***Delegated Decisions by Cabinet Member for
Environment (including Transport)***

OXFORD – ACCESS TO HEADINGTON: FURTHER CONSULTATION ON TRAFFIC MEASURES

DIDCOT – COW LANE, TYNE AVENUE & EVENLODE DRIVE: PROPOSED WAITING RESTRICTIONS

BRIZE NORTON – CARTERTON ROAD & STATION ROAD: PROPOSED TRAFFIC CALMING MEASURES

a) Elms Drive – approximately 7.9m long and 6m wide

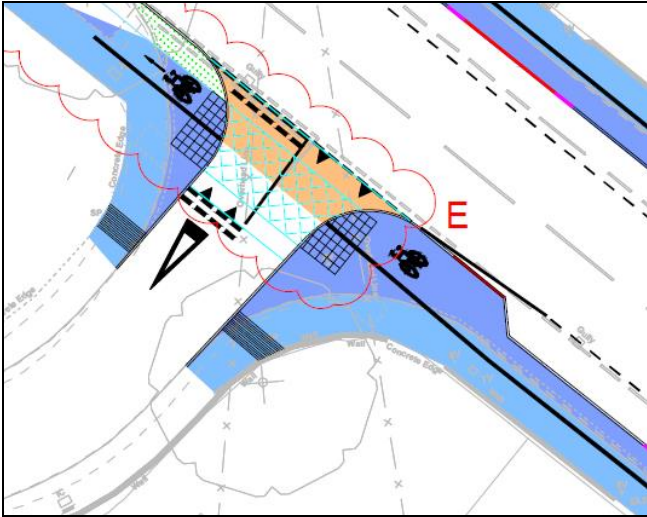
Despite the reduced radii, this junction is compromised and unacceptable without the ramp shown in the drawing as the radii are still too generous for a quiet residential road.

We welcome the effort to maintain a level and continuous footpath and cycleway. However, Cyclox would urge the council to change the material to reflect the continuity of the new cycle-path. The current edge to the vehicle path, provided by the buff anti-skid surface, reduces the 'pavement-ness' of the crossing. It needs to be extended to provide the visual cue that the footway and cyclepath are continuous, have priority, and to help solve the encroachment issues.

The material used needs to continue unbroken and well beyond the junction with no materials or structures indicating the edge of the space to be used by vehicles. It needs to be the same height as the footway in relation to the road with no kerbs or kerb-like structures to highlight the line to be taken by vehicles. Ideally the end of the side road should narrow to one car width to highlight this feature as vehicles approach the main road.

b) Ewin Close – approximately 8.1m long and 5.3m wide.

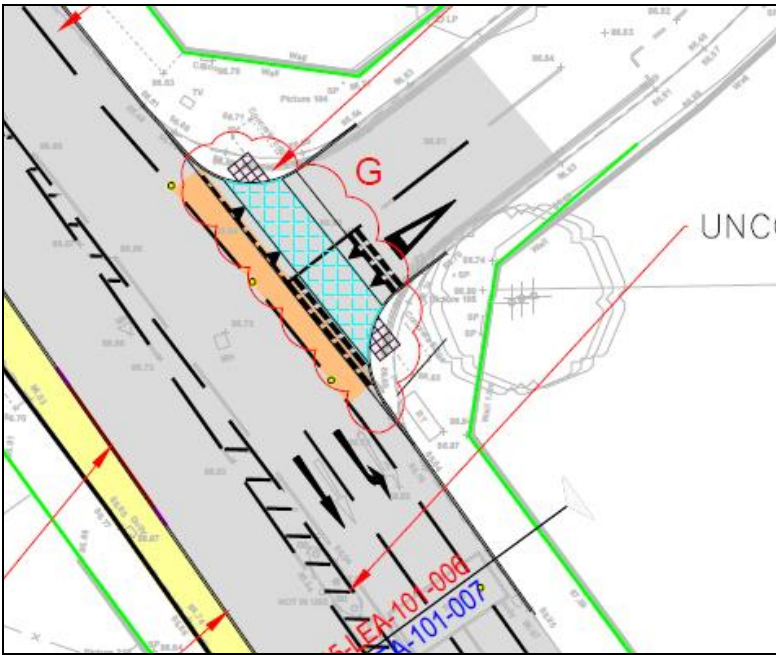
This junction is as compromised as Elms Drive.

We would again object to the lack of continuity in level and material across the raised-table to reinforce visually that the footway and cycle-path have priority as seen in picture 1 and 2 above, as well as the removal of the vehicle path edge (indicated by the kerb-like radii and DRLs) that can be seen in picture 4.

b) Eden Drive – approximately 9.9m long and 3.6m wide

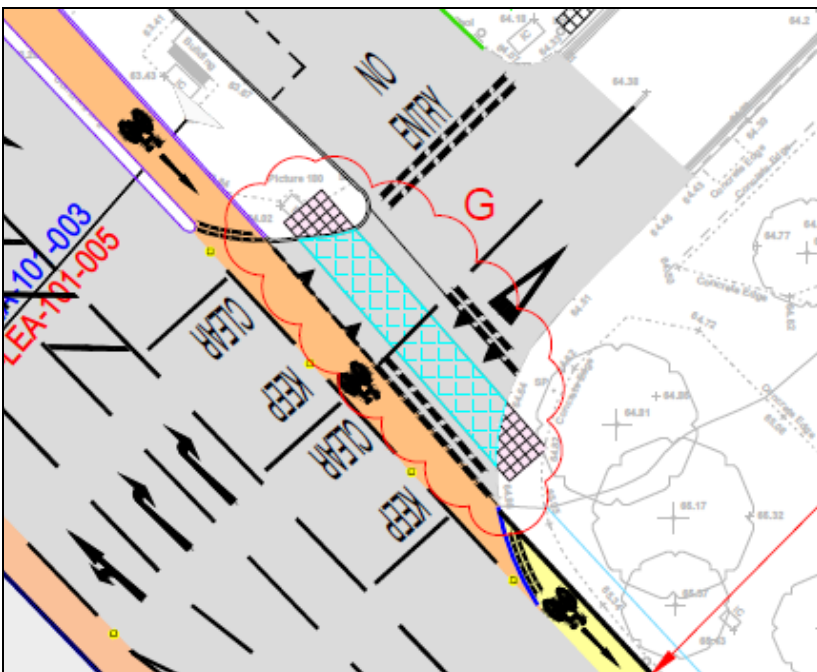
As this cycle path is already on road we would like to see the footway continuous in both level and in material to reinforce the pavement with no vehicle edge. This would enable a safer crossing for both pedestrians and cyclists alike.

We note that there is no cycle symbol, as proposed for Snowdon Mede and Cope Lane, following.

c) Cope Lane – approximately 8m long and 6.4m wide

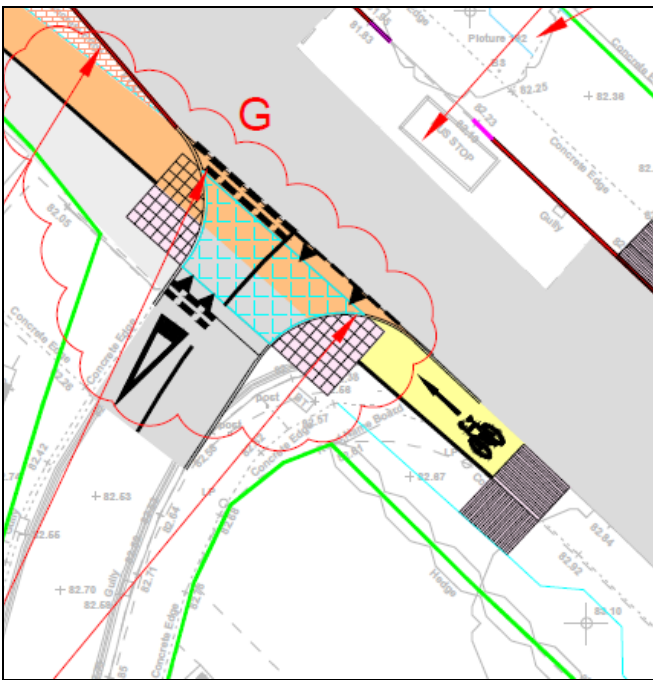
The cycle give-way line markings are not acceptable, they provide a vehicle edge and undermine what is the most promising aspect about this junction – its full segregation in space and time. A cyclist having cleared the major junction then has to look both behind and forwards simultaneously and then possibly yield whilst essentially being on the main carriageway, even if travelling less quickly than motorised traffic. This is a major impediment to continuity and effectively creates an unacceptable 'dual network' (a concept which is to be removed from the provisions in the

forthcoming replacement for LTN2/08¹) and negates any advantage of the segregation. This junction is not coherently designed and it should have the same cycle priority as the junction at Eden Drive. As can be seen below, the table is needed to stop cars using the cyclepath as the give way.

d) Cholesbury Grange – approximately 5.3m long and 3.1m wide.

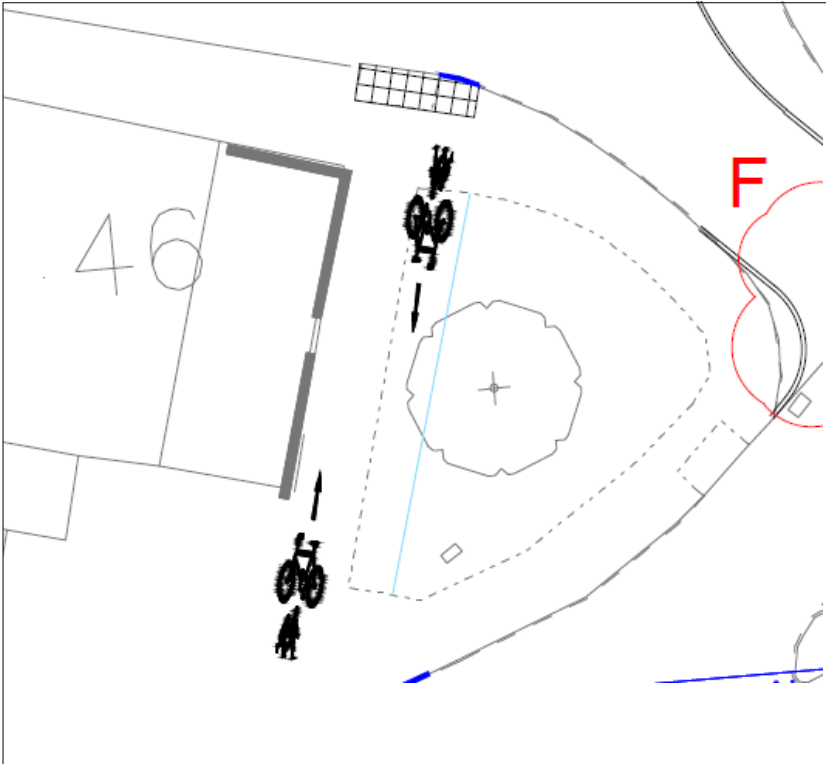
We would like to see the footway and cyclepath continuous in both level and material to reinforce the pavement, with no vehicle edge provided by the kerb-line.

The kerb-line indicates to drivers ‘their space’, which is counter to the priority proposed for cycling and walking.

ANNEX 1

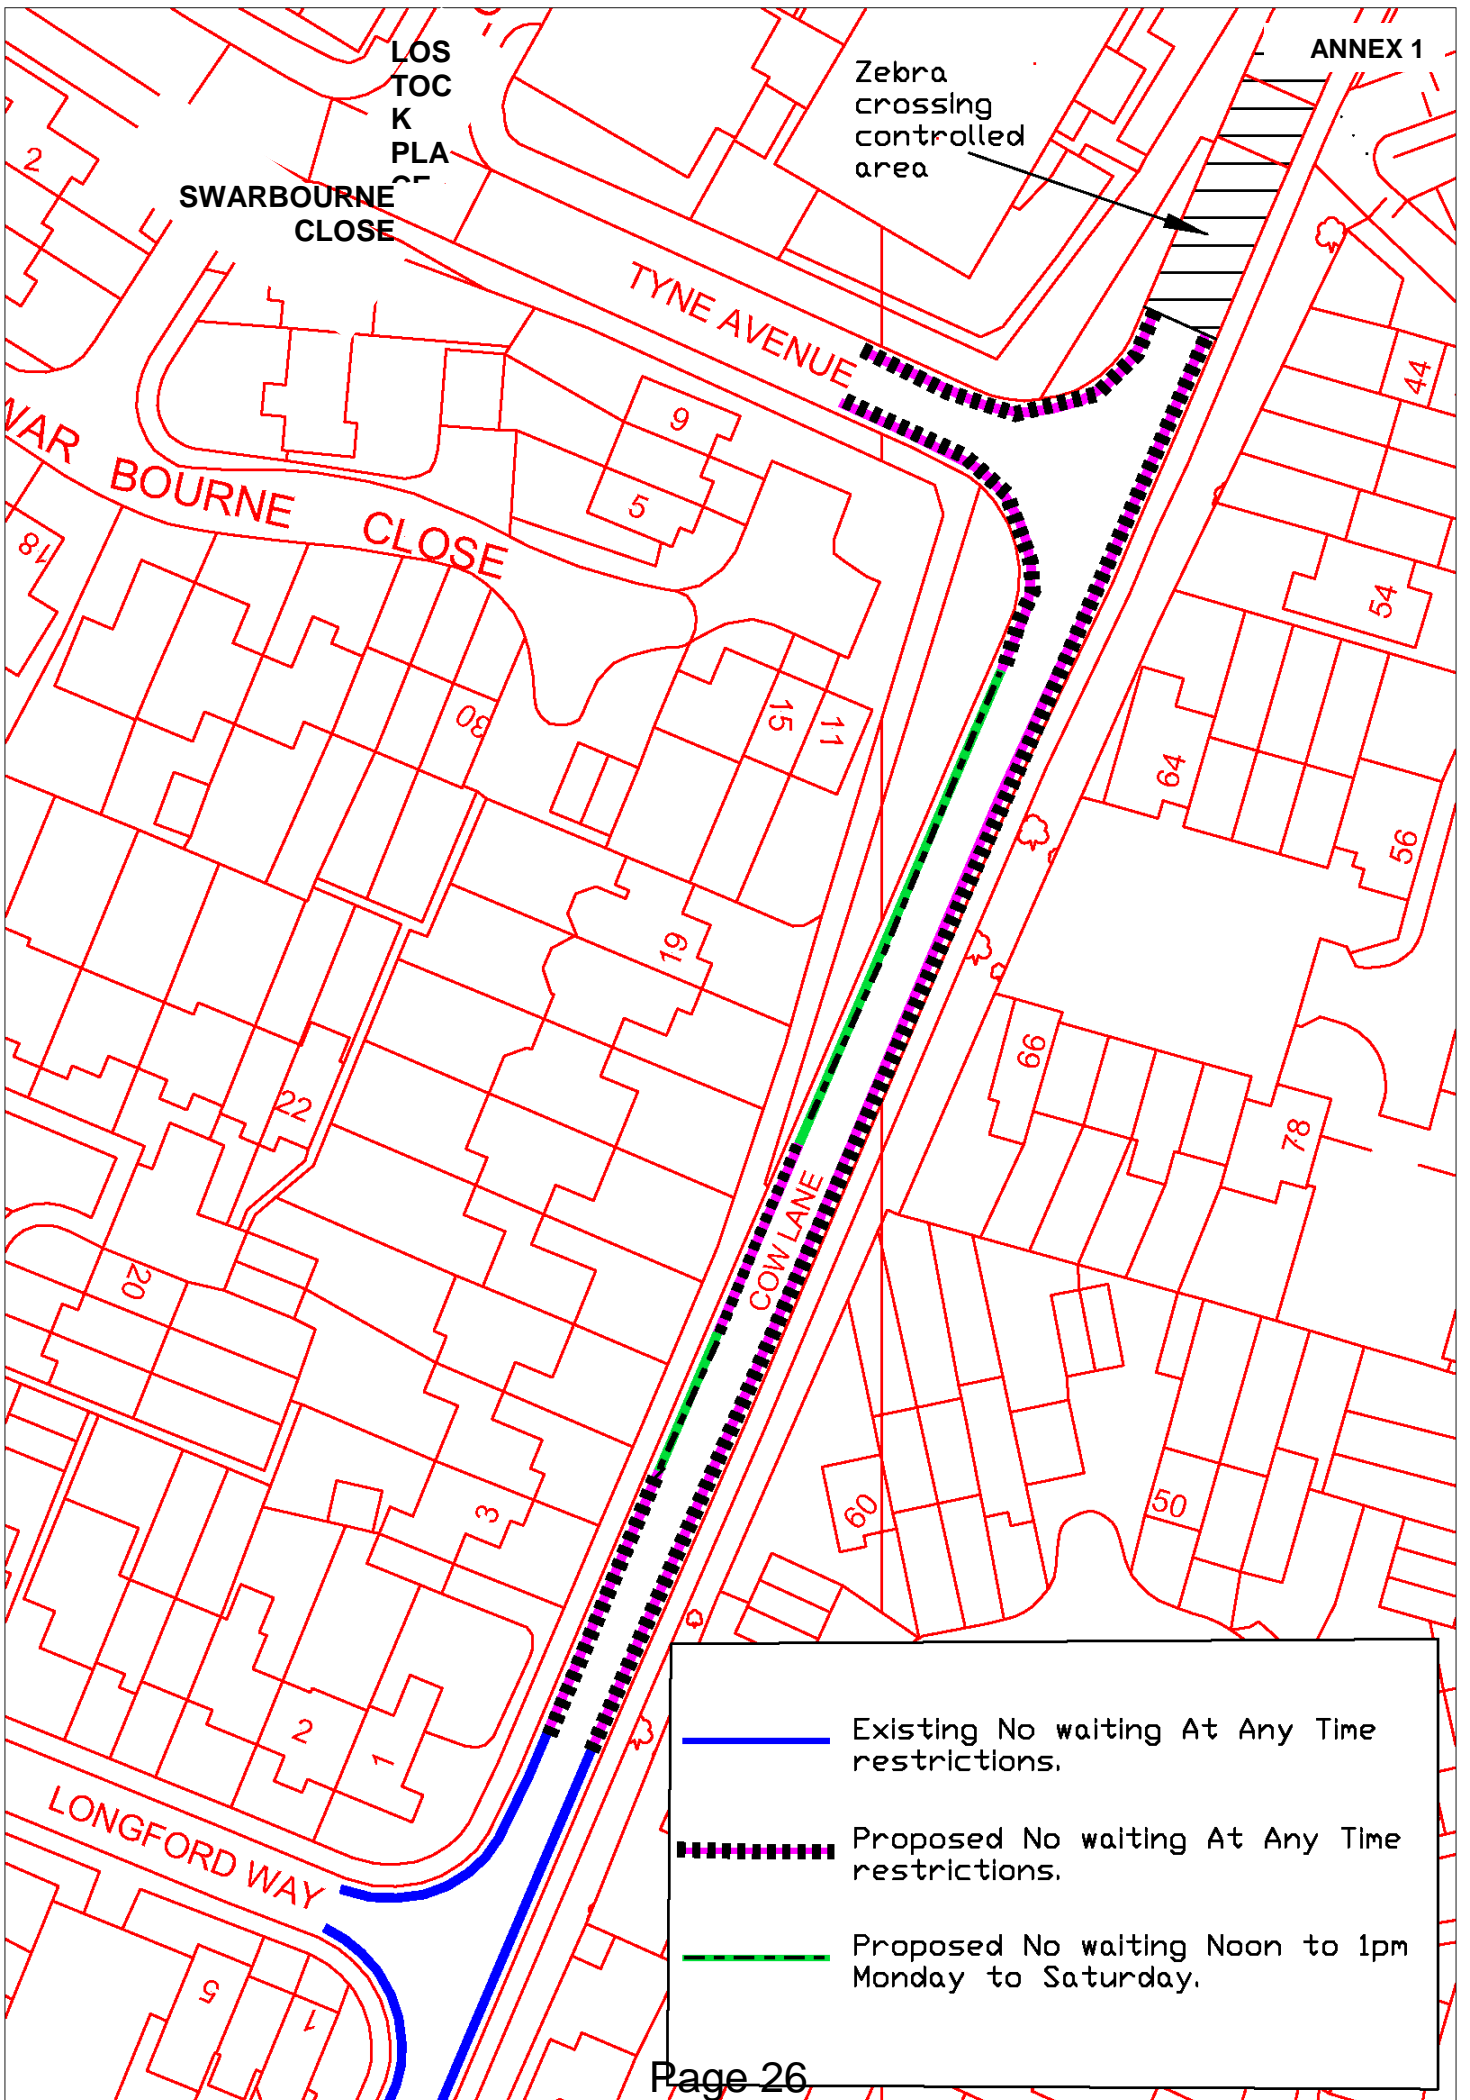
(2) Didcot Town Council	<p><u>Cow Lane</u> – Support <u>Tyne Avenue</u> – Object <u>Evenlode Drive</u> – Support</p> <p>Didcot Town Council is concerned that the restriction proposed for Tyne Avenue is not sufficient to remove the problems with parking along the road. The restrictions planned would merely move the problem further down the Avenue, where there is no restriction planned. Didcot Town Council requests that the planned restriction be strengthened by extending it, at least to as far as the junctions with Lostock Place and Swarbourne Close.</p>

<p>(5) Local Resident, (Didcot)</p>	<p><u>Cow Lane</u> – Object <u>Tyne Avenue</u> – Object <u>Evenlode Drive</u> – Object</p> <ol style="list-style-type: none"> 1. I do not believe the marked green lines on the West side of Cow Lane are accurate as they cover the single access/egress for houses 19 - 9. 2. I would strongly advise that the Prohibited parking times noon -1pm areas on the west side of Cow Lane are not long enough this should be at least 9am - 3pm as the Road is often used as overflow parking for the Orchard Centre visitors and Staff and not just Rail commuters (I see it every day). 3. Why no Sunday Restrictions!!! We still have to access the Single drive and often the Road is Full (Orchard Centre & Rail Commuters) Sunday is a normal day.

<p>4. Once the new development at the West side of Ladygrove is in use the Restrictions as proposed won't work as it's only 1 hr leaving it free for parking for the other 23hrs! Trains run late and shops stay open late.</p> <p>4. Why are full double lines with all these restrictions not being considered for the whole proposed area. By introducing the Marked green prohibited & timed areas you're not solving anything and as such as someone who has lived with this traffic issue for many years, I think the Plan is Flawed, unless my points above are addressed.</p>

9. In response and after confirming with the County Council's Legal team that a further consultation is not required, this request can be agreed and implemented.

11. In response to the first point an informal consultation was undertaken by the Local Member during April & May 2019 which demonstrated that most residents favoured single yellow lines with an hour's prohibition at lunch time (or slight variant), as proposed.

12. In response to the second point, the anti-social commuter parking is not believed to be a significant issue on Sundays.
13. In conclusion the proposed balanced restrictions should improve drivers' sightlines by removing dangerous and obstructive parking, whilst also providing the residents of nos. 3 to 19 Cow Lane, who have shared driveways, with some 'on street' overflow/visitor parking availability.

Drawn by: 3694/190

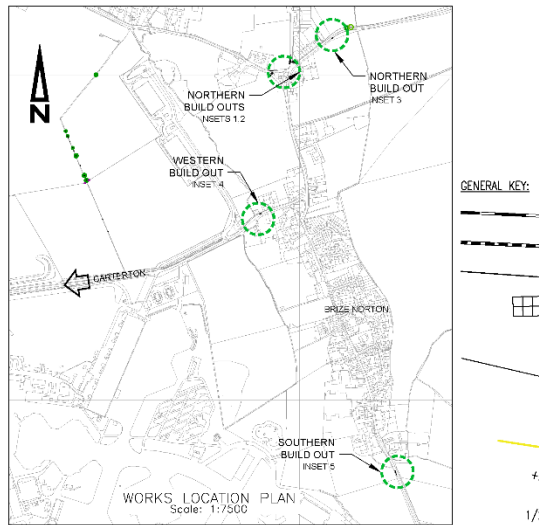
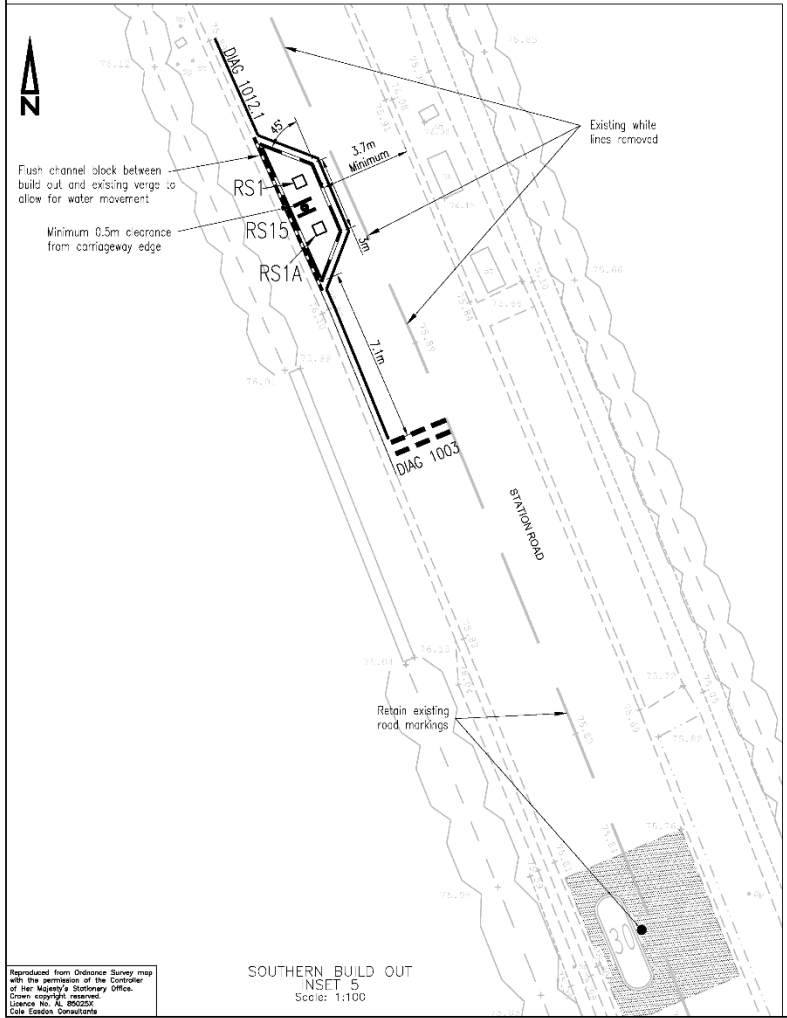
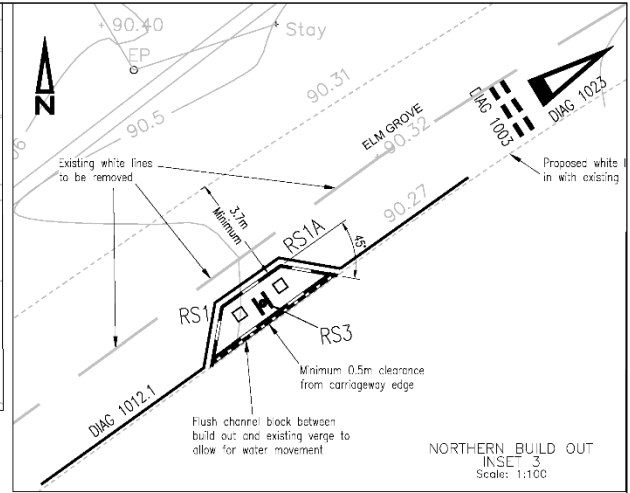
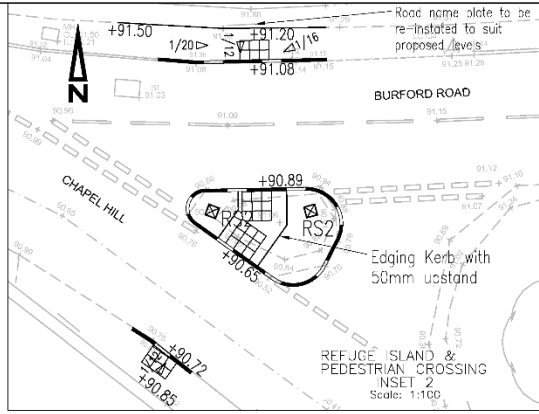
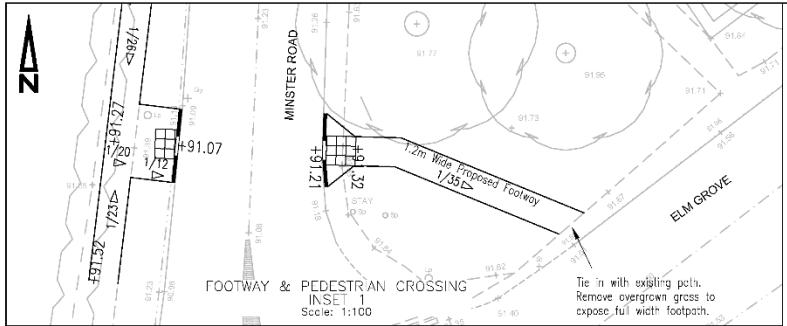
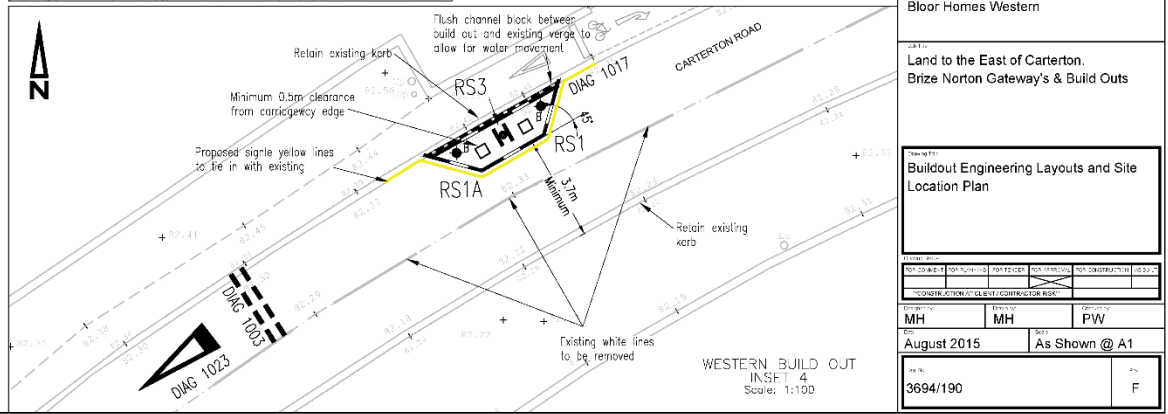
RESPONDENT	SUMMARISED COMMENTS
(1) Traffic Management Officer, (Thames Valley Police)	<p>No objection – I would like OCC to monitor the sites especially where approach speeds to some of these features could be high and drivers try and race through when seeing other vehicle approach in the opposite direction. I assume these features will be lit and comply with the sight line requirements which is essential in these rural applications?</p> <p>Thames Valley Police have no objection to the plan subject to the comment in this response.</p>

(3) West Oxfordshire District Council (Planning & Strategic Housing)	<p>No objection</p>
(4) Local Resident, (Brize Norton)	<p>Object – I am very concerned that the traffic calming measures do not include the Minster Road itself. At the present time traffic comes across the roundabout at the top of Manor Road and accelerates from there towards the A40. In the opposite direct the traffic doesn't slow down until it reaches the roundabout. Admittedly the length of Minster Road is not great but its amazing the speed the traffic can get up to going in and out of the village.</p> <p>I can't see anything in the proposals that will help that. As much as the CC like to think that traffic uses Monahan way it doesn't. It's much quicker to access Carterton via Brize Norton Village. I would like to think that, for once, we are actually classed as part of the village instead of an offshoot. The noise of the traffic crashing over the cushions in Minster Road is particularly intrusive. A lot of the commercial vehicles that access Viscount Court and Timms Builders Merchants do so via Minster Road, most of which have contents that leap up and crash down going over the cushions. It doesn't get much quieter at night either.</p>

<p>(5) Local Resident, (Brize Norton)</p>	<p>Object – Carterton Road - The build out looks to be sited in an area in close to multiple houses and driveways. This raises additional road safety concerns. The build out, bollards and signs will obstruct the view of cars both on the road and exiting driveways (specifically 18-26). Increasing the likelihood of an accident.</p> <p>On top of this, due to the possibility of cars exiting driveways and proceeding westbound there is opportunity for further accidents with cars travelling eastbound at the buildout due to possible confusion regarding right of way. On top of the safety concerns, there will be increased pollution, in the form, of particulate (brake and tyre), exhaust emissions (additional acceleration) and noise (both braking and acceleration) at the buildout which is in close proximity to multiple houses.</p> <p>Elm Grove - No concerns regarding the pedestrian build. Concerns over buildout as per Carterton Road.</p> <p>Station Road – Concerns as above, as well as questioning need for this. Multiple cars are usually parked in proximity to this location on the road. In effect creating a traffic calming measure without the time and expense of the build.</p>

11. In response to the above concerns, traffic calming build-outs have been widely used in the county with the great majority operating with very good levels of safety and with very low levels of concern being expressed over noise and air quality, noting that the properties in the immediate vicinity of the build out were set well back from the road.
